VTM COMPLIANCE EXHIBITS
 TITLE PAGE
 MIRAMONTE
 SOLEDAD, CALIFORNIA
 APRIL, 2021

VTM COMPLIANCE EXHIBITS
KEY MAP
MIRAMONTE
SOLEDAD, CALIFORNIA
APRIL, 2021

VTM COMPLIANCE EXHIBITS
AREA 1 & 15 AT LINEAR PARK
 MIRAMONTE
 SOLEDAD, CALIFORNIA
 APRIL, 2021

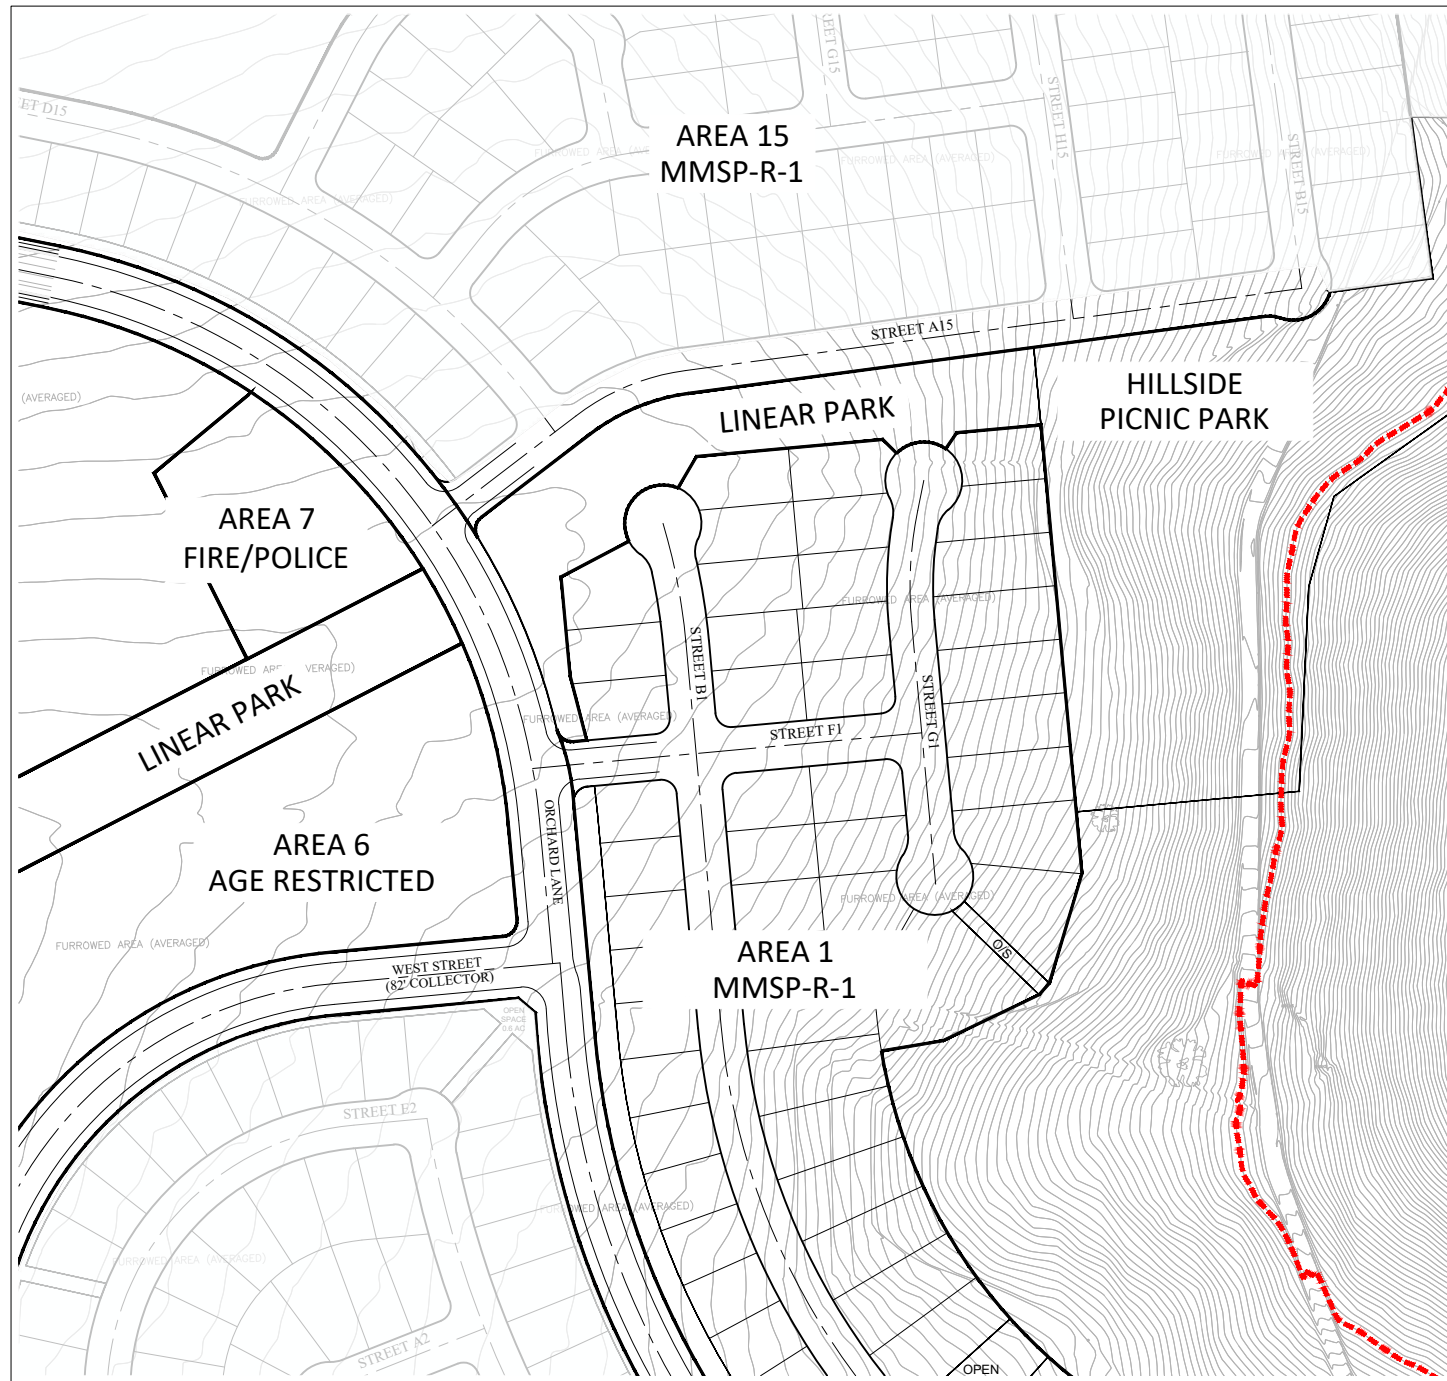
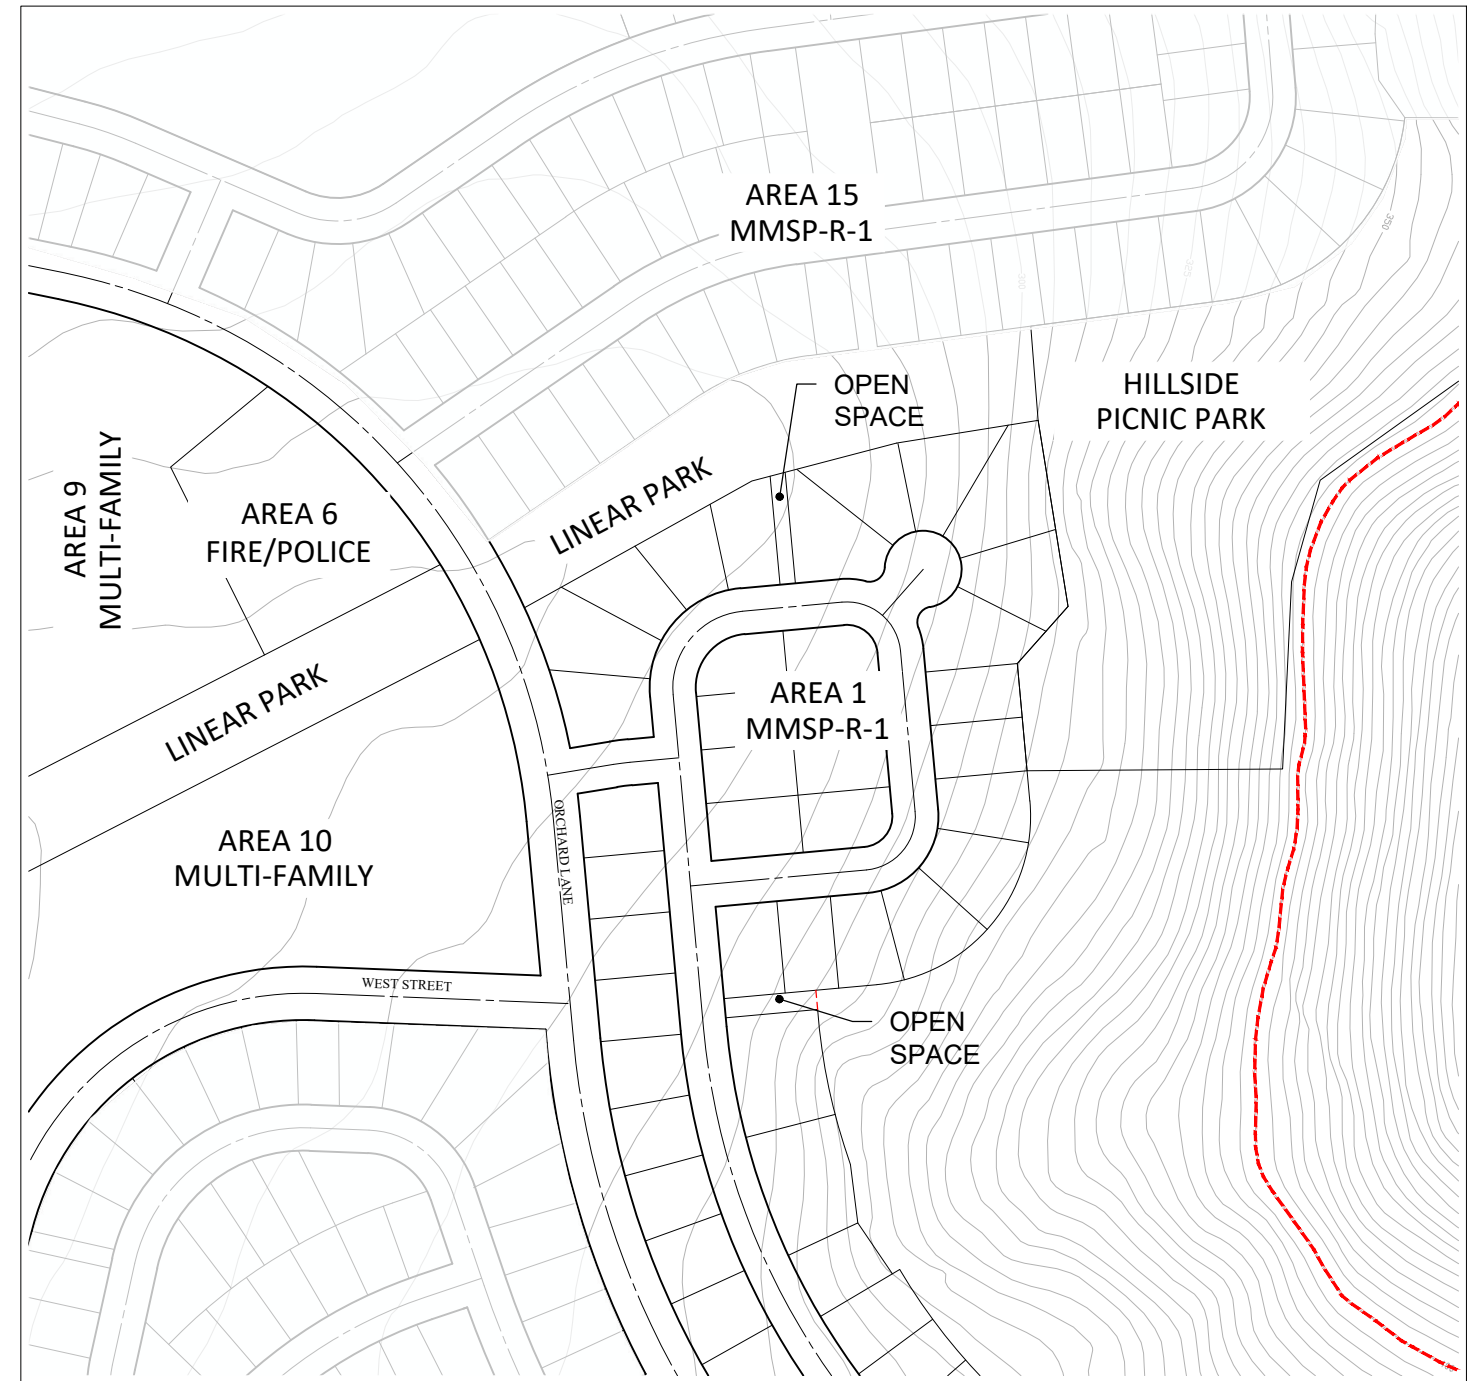
1. CUL-DE-SACS USED IN AREA 1 TO OPEN THE RESIDENTIAL NEIGHBORHOOD TO THE LINEAR PARK
2. FRONTAGE ROAD ADDED IN AREA 15 TO OPEN THE LINEAR PARK TO THE NEIGHBORHOOD.
3. ELIMINATED THE LOTS BACKING ONTO THE LINEAR PARK IN BOTH AREA 1 AND AREA 15
4. INCREASED THE CENTERLINE RADII OF ORCHARD LANE FOR REASONABLE DESIGN SPEED
5. INCREASED THE ROW FOR ORCHARD LANE AND WEST STREET TO ACCOMMODATE THE TWO-WAY LEFT-TURN LANE RECOMMENDED BY THE CITY'S TRAFFIC CONSULTANT
6. OPEN SPACE ADDED ALONG ORCHARD LANE TO ACCOMMODATE GRADE CHANGES AND PUE AREA

VTM COMPLIANCE EXHIBITS
 AREA 15
 MIRAMONTE
 SOLEDAD, CALIFORNIA
 APRIL, 2021

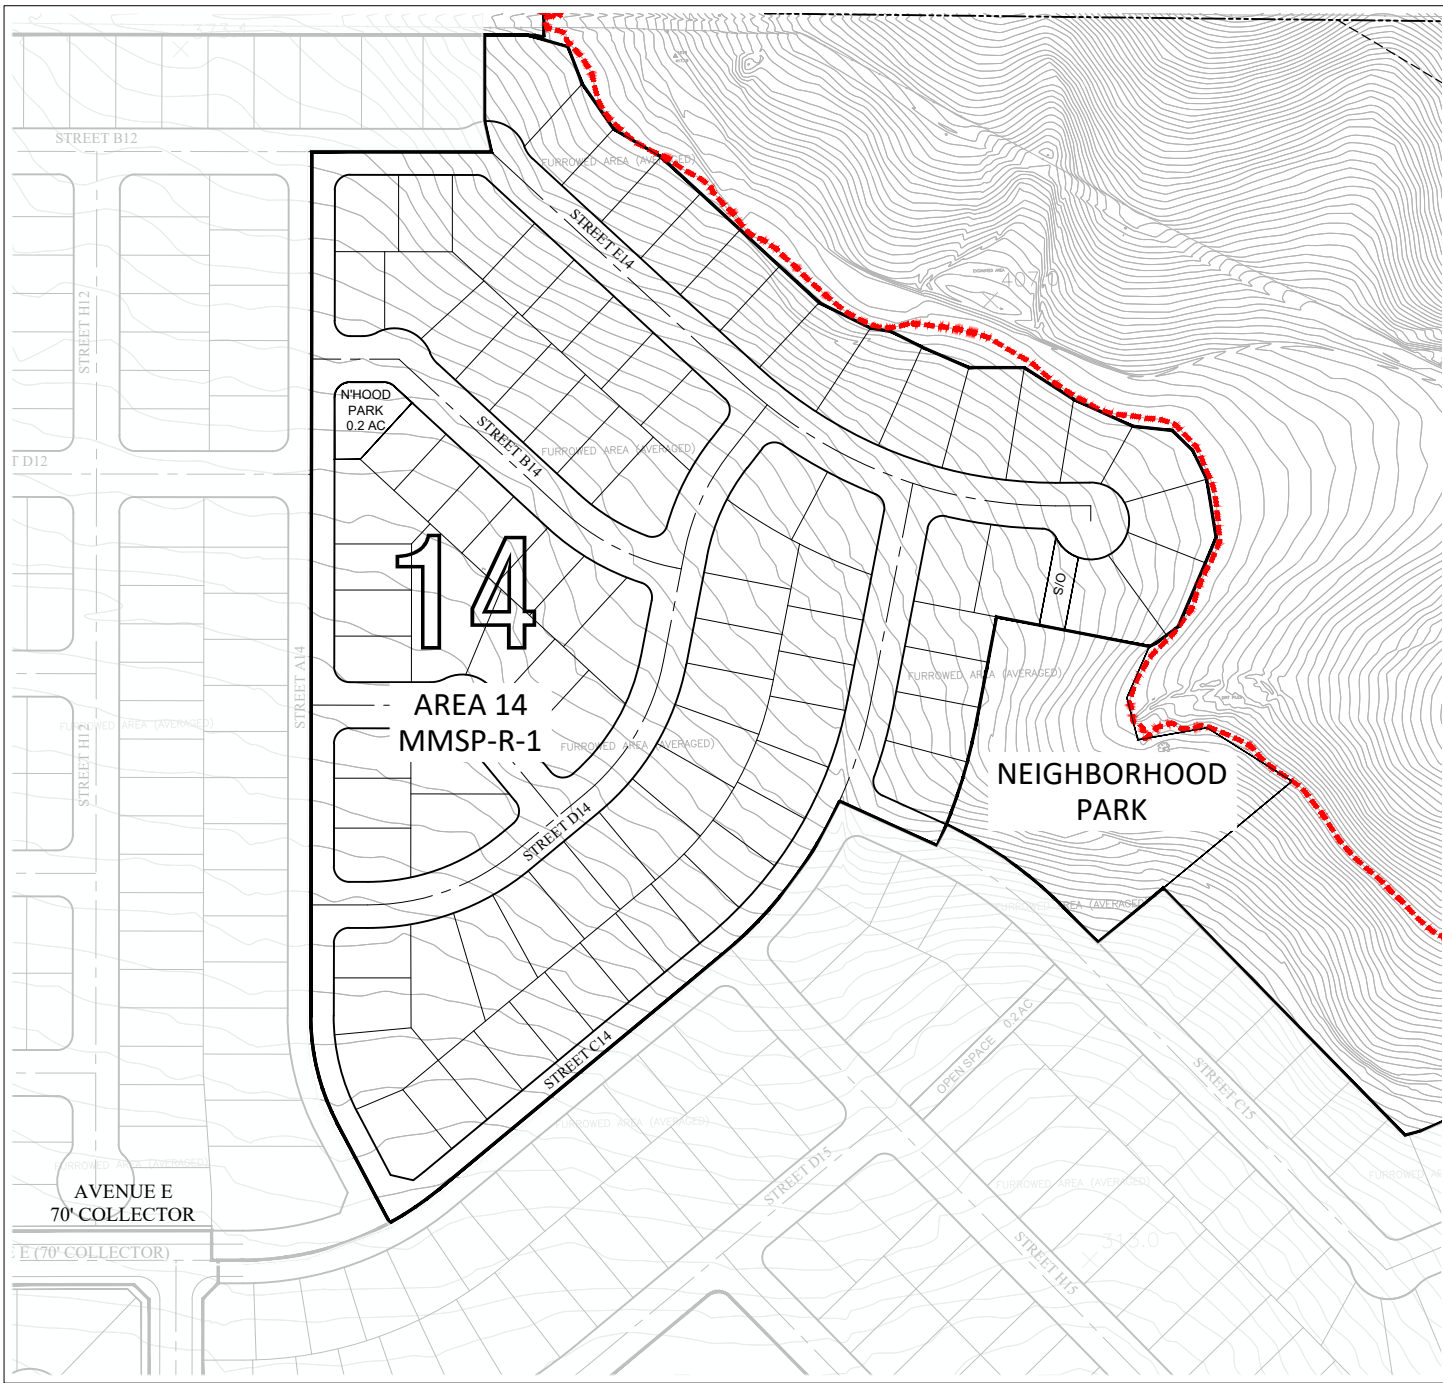
NOTES
MINOR STREET & LOT LAYOUT REVISIONS TO ACCOMMODATE GRADING

VTM COMPLIANCE EXHIBITS
 AREA 14
 MIRAMONTE
 SOLEDAD, CALIFORNIA
 APRIL, 2021

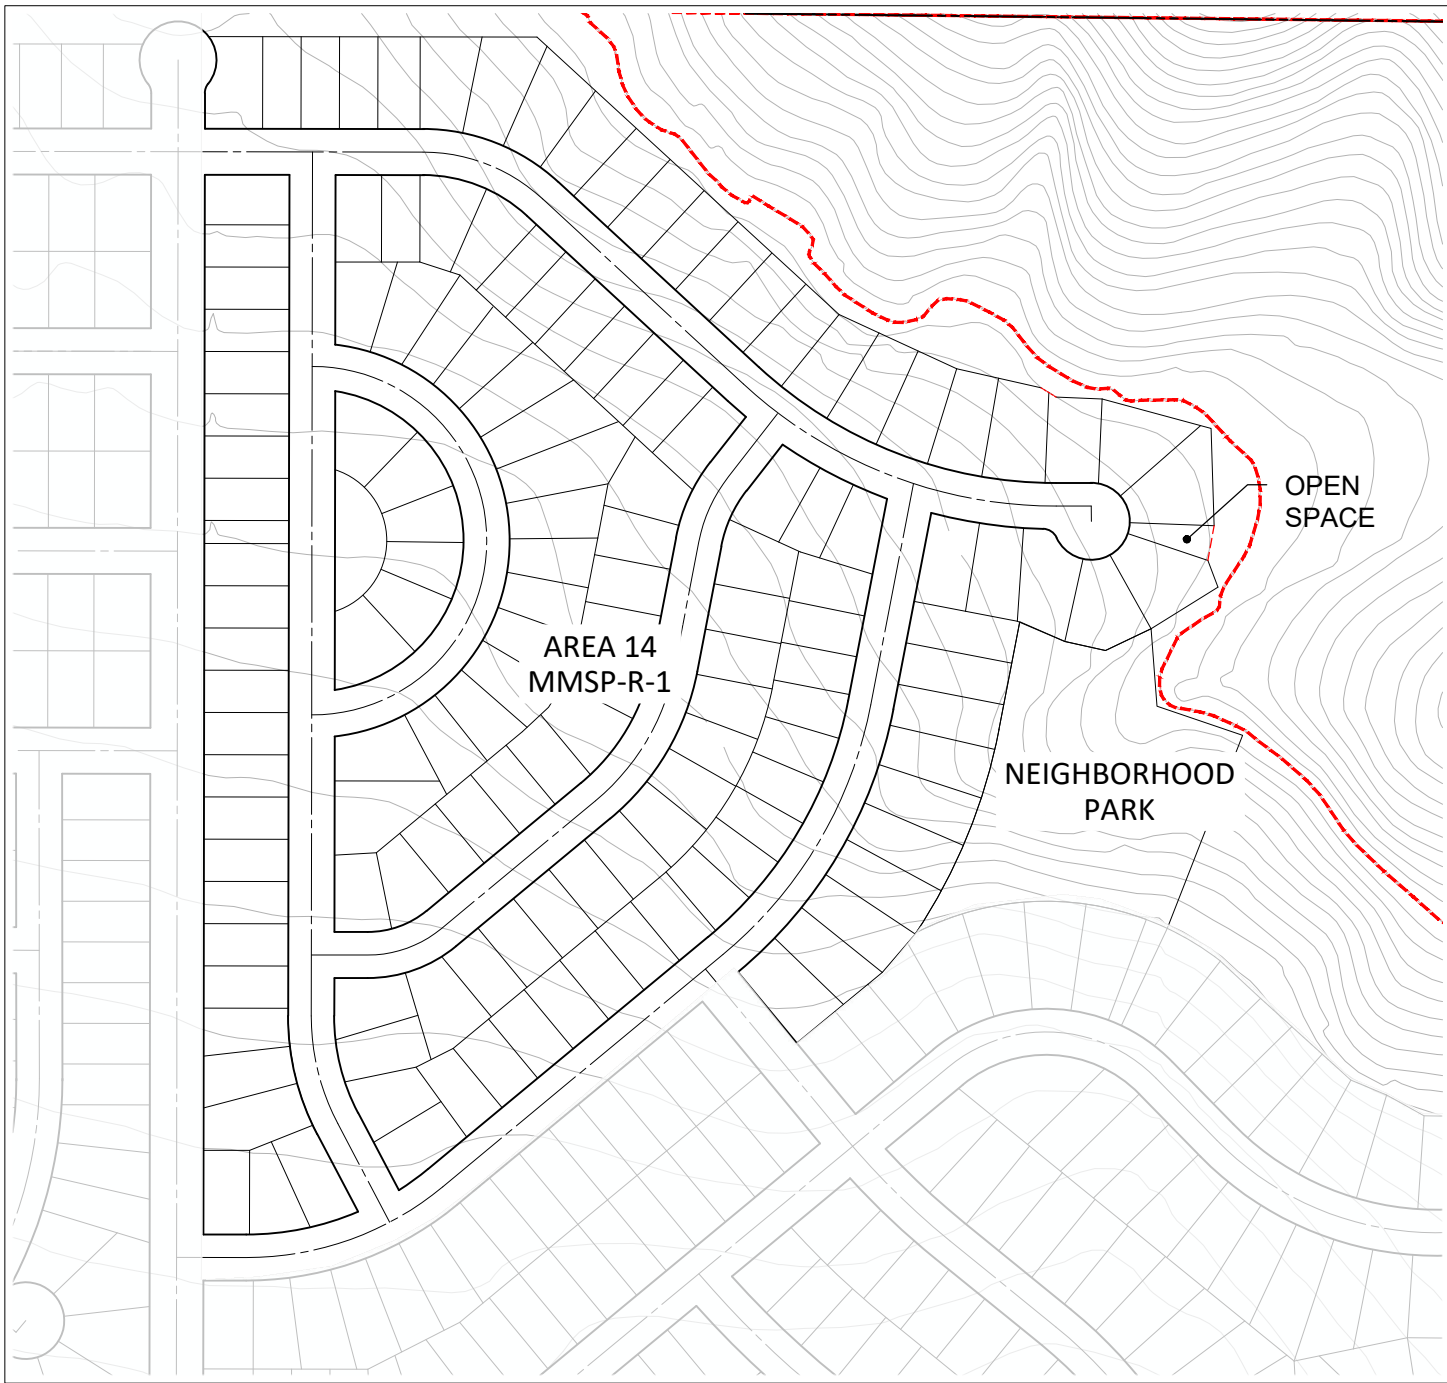
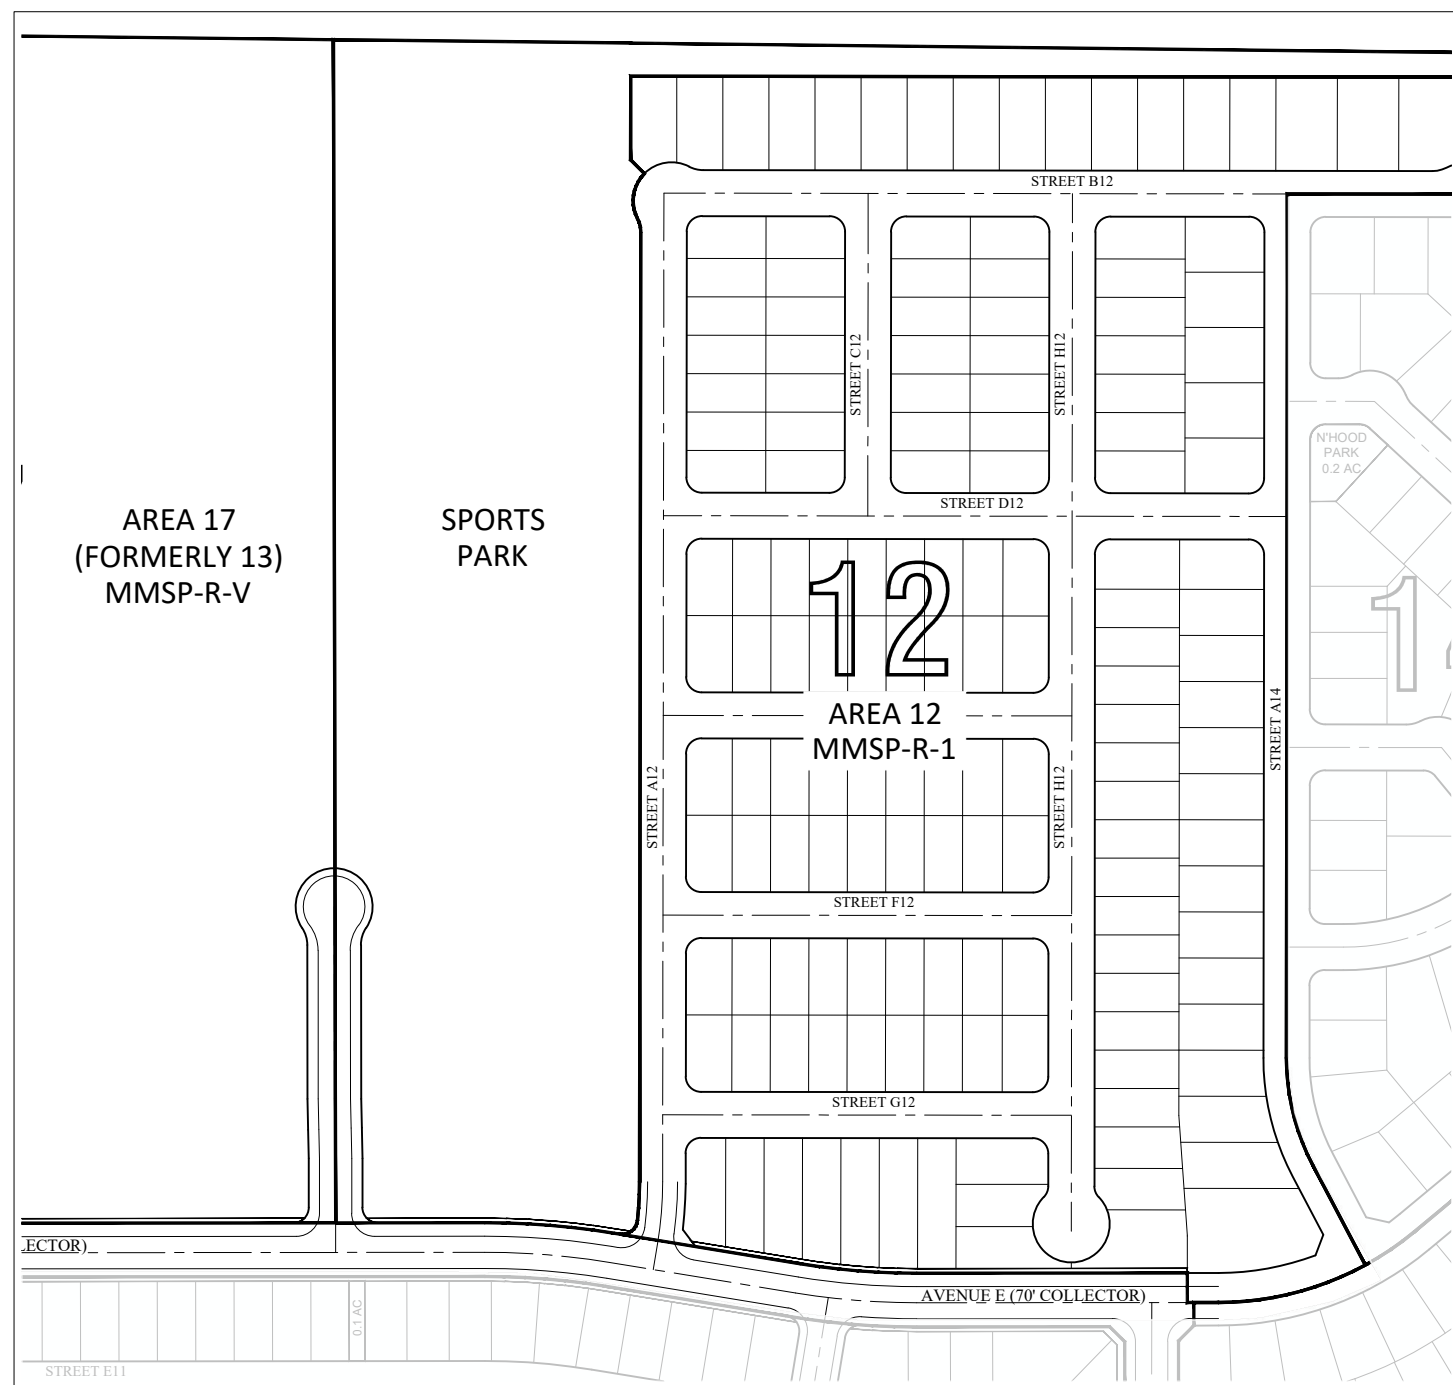
- 1. STREET AND LOT LAYOUT REVISIONS IMPROVED STREET FRONTAGE ACCESS TO THE NEIGHBORHOOD PARK BACKING ONTO THE HILLSIDE.
- NOTE THAT THIS PARK ON THE 2018 VTM WAS LAND-LOCKED WITH NO STREET FRONTAGE
